KAMAYA ELECTRIC SLITLINE MEASUREMENT CONTROL & STANDARD

DATE : 26th AUG 2016

1. SAMPLE VERIFICATION

SLITLINE MEASUREMENT METHOD

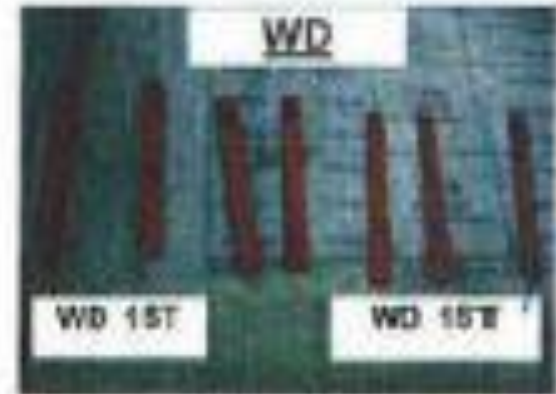
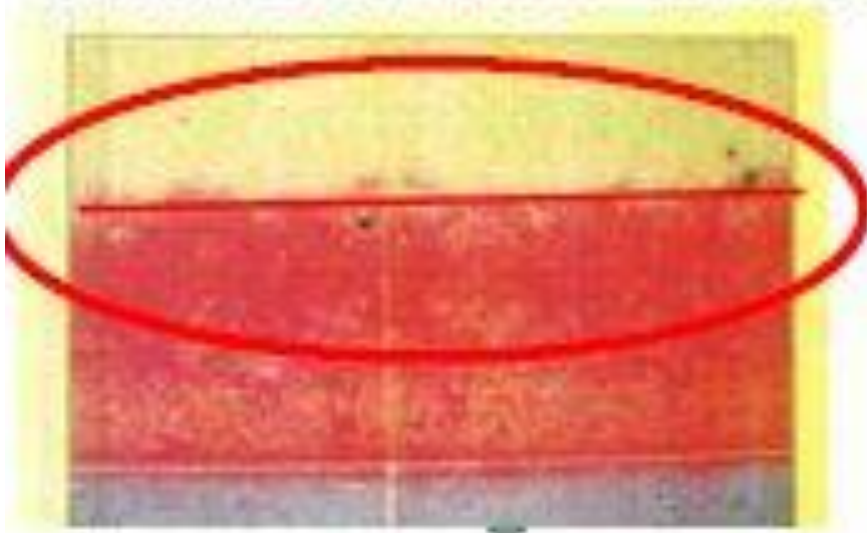
Measurement point is between highest peak & lowest peak. In other words, the cross line will be on the average point

WD TREND : LOT NO: DE-16, HG-12 & MT-24

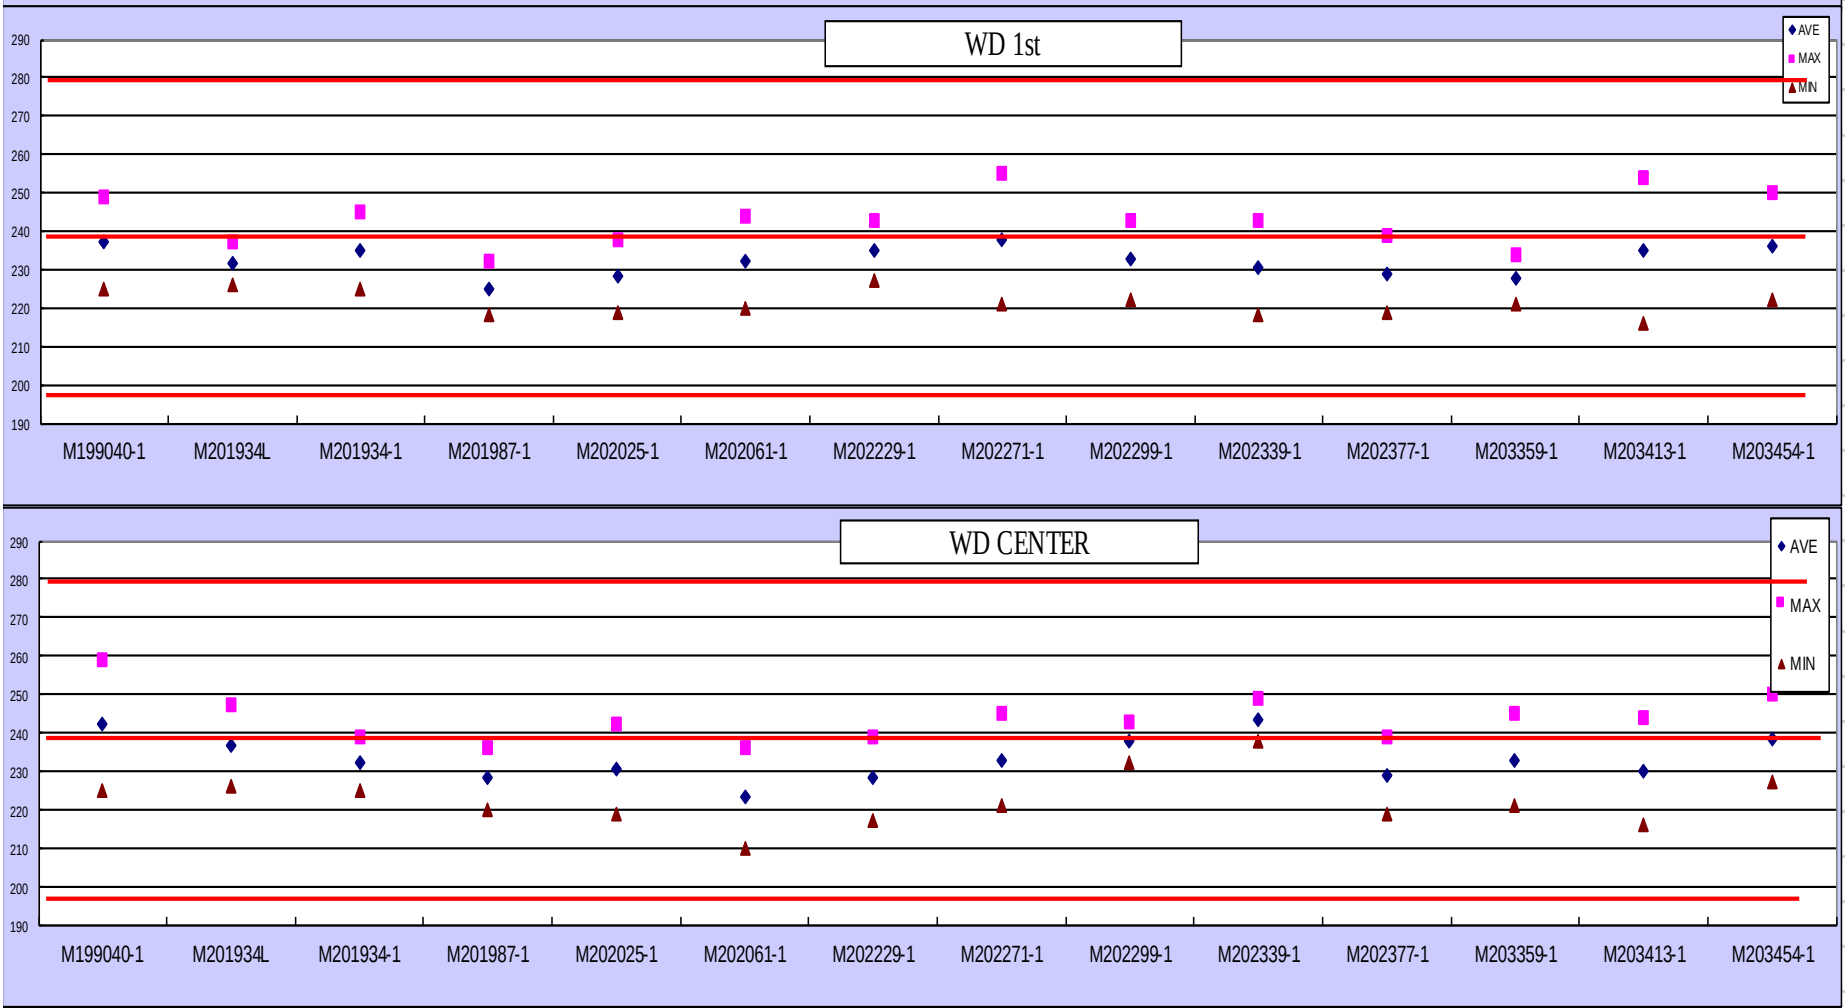
- 1. Kamaya's slit line measurement inconsistent and is difficult to judge whether is deep or shallow
- 2. The product produced will impact on other customer (breakage issue – shallow – KAMAYA method))
- 3. Overall all NG sample are within the drawing spec (MARUWA method)

- 1. MARUWA propose to remain the current measurement method for slit line**
 - 2. Change of method will impact on other customers verification on slit line**
 - 3. The different method product not able to shipout to other customers (RISK of breakage issue)**
-
